**PLANNING AND DEVELOPMENT SERVICES STAFF REPORT**

**For Planning Commission Meeting of January 22, 2020**

**SUBJECT: Michigan Schools and Government Credit Union Special Exception Use and Landscape Modification for City Planning Commission Approval, and Zoning and Site Plan for City Council Approval  
(2151 West Stadium Boulevard)  
Project Nos. Z19-010, SEU19-003, and SP19-019**

**SUBJECT: Michigan Schools and Government Credit Union Special Exception Use for City Planning Commission Approval, and Zoning and Site Plan for City Council Approval  
(2151 West Stadium Boulevard)  
Project Nos. Z19-010, SEU19-003, and SP19-019**

TITLE:  
**SITE PLAN**

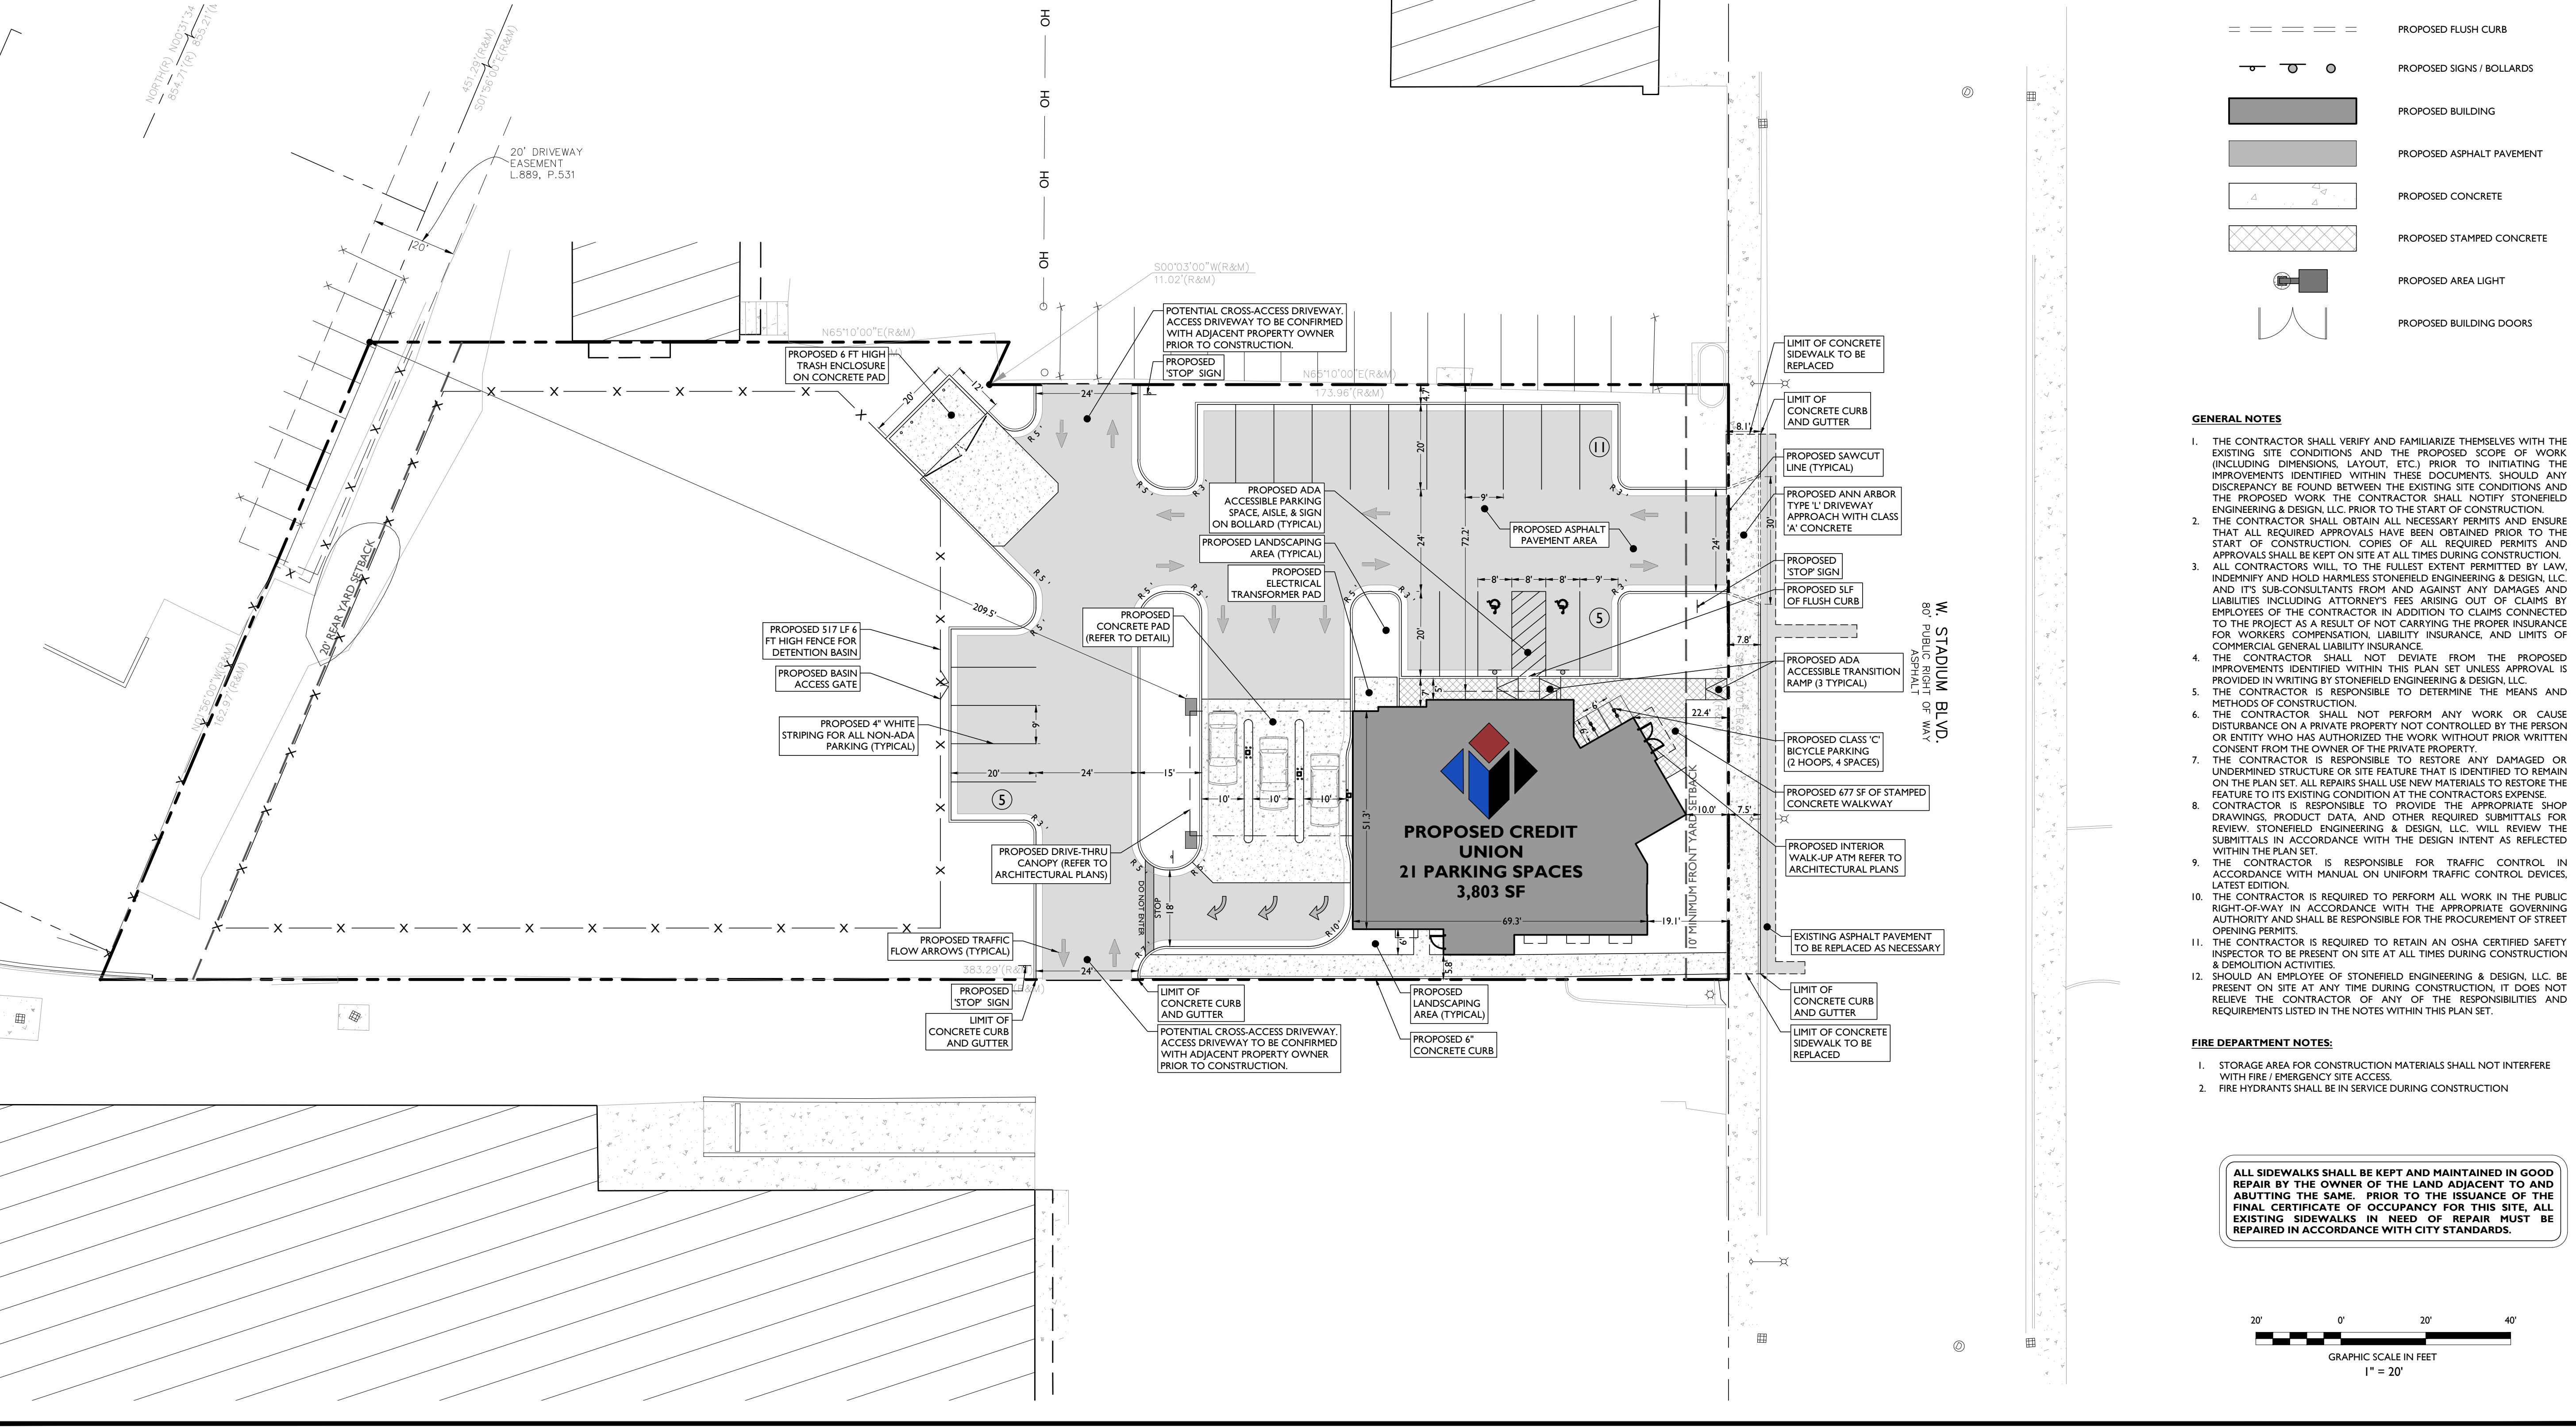
- Adjusted the landscaping and tree species adjacent to the entry drive and adjacent to the drive-up lane approach. Tree branches are now shown trimmed to a certain height.
- A drive running north/south has been clarified as 24' wide and connects to both adjacent sites.
- A sidewalk was added along part of the south edge of the site near the building.
- The loading zone was removed to reduce the impervious surface area.

Planning: The cross-access driveway is appreciated. If, at the time of construction, the adjacent property owner(s) do not authorize this vehicular access onto their property, MSGCU would install a straight curb across the opening. Before access is possible onto adjoining sites, a cross-access easement will be required.

Planning Staff Comments: The petitioner has shown a driveway connection to the property to the south on their site plan. This is much appreciated, and though that landowner is not currently interested in making a physical connection, it preserves that potential for the future. Staff also suggested a connection to the north and that some parking spaces be deferred, which the petitioners declined due to their proposed site layout and perceived need for the maximum number of parking spaces.

Planning Staff Comments: The petitioner originally submitted a site plan showing a driveway circling the building and running between the sidewalk in the Stadium Boulevard right-of-way and the credit union building. Planning staff noted in the first round of review comments that the configuration of the driveway was unnecessarily hazardous to pedestrian by forcing all traffic on site (not just drive-through traffic) to circle the building via the front yard. Because of the large size of the lot and small building footprint, staff recommended that the drive be relocated behind the building to minimize the potential for pedestrian conflicts. The petitioner met with planning staff, then changed their site plan to the current configuration by moving the building closer to West Stadium Boulevard and creating a loop drive behind the building.
